LCNF Competition ENWL FLARE

Interrogation Report

Document No. : FNC 45646-41687R

Client : Ofgem

Appendix A1 DECC
Low Scenario 4.docx

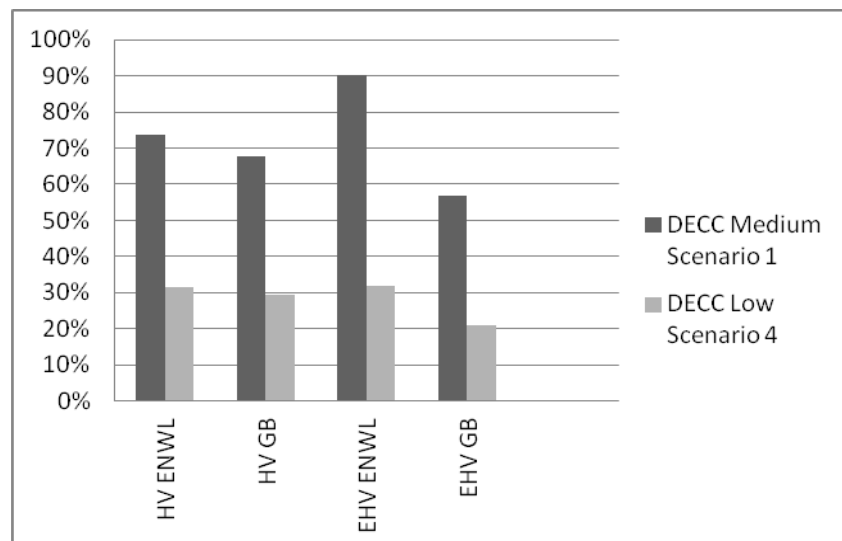
Criterion (A) – Accelerates the development of the low carbon energy sector and has the potential to deliver net financial benefits to existing and/or future customers;	
Sub-criterion (a.i) – Ability to facilitate the Carbon Plan through GB wide roll out.	Challenge 1: The submission states that all three methods could allow HV substations to gain the theoretical maximum of 23MVA of additional capacity, and all EHV substations 90MVA of additional capacity. When calculating the percentage of all sites across GB that would be applicable for the scheme in order to determine the total capacity released, ENWL has provided more information regarding primary substation break fault level as a percentage of switchgear rating for its own network than the whole of GB (excluding Manweb) – see the answer to clarification Question 11. Over 30% of ENWL substations and about 44% of GB substations have less than 50% of the expected fault current as a percentage of their rating. The number of appropriate applications of the FLARE methods (Appendix A1 of the pro-forma) appears optimistically high especially between 2030 and 2050. Information of the level of confidence, or minimum and maximum bounding figures, for the number of applicable sites, and therefore the impact on the confidence of the estimated total released capacity would assist in this evaluation.

Answer 1: The figures used in the submission Appendix A1 for 2020 to 2030 and 2030 to 2050 are based on ENWL load forecasts for DECC 'Medium' scenario 1, with high heat pump adoption, medium EV take up, medium PV take up and no DSR take up. We would regard these figures for the number of applicable sites as close to the maximum bounding figures. We would expect the DECC 'High' scenario 3 (with high heat pump adoption, high EV take up,

high PV take up and no DSR take up) to provide the maximum bounding figures. To provide minimum bounding figures, we have revisited the calculations using ENWL load forecasts for DECC 'Low' scenario 4, with low heat pump adoption, low EV take up, low PV take up and no DSR take up.

The resulting figures are much lower for 2030 to 2050 in particular, please see the attached document. This contains a revised table and shows the difference between DECC 'Medium' scenario 1 and DECC 'Low' scenario 4. A move to low carbon technologies represents an increase in demand and fault level, the only difference in the various DECC scenarios is the rate at which substations reach their switchgear fault rating, and hence the rate at which the FLARE methods can be applied.
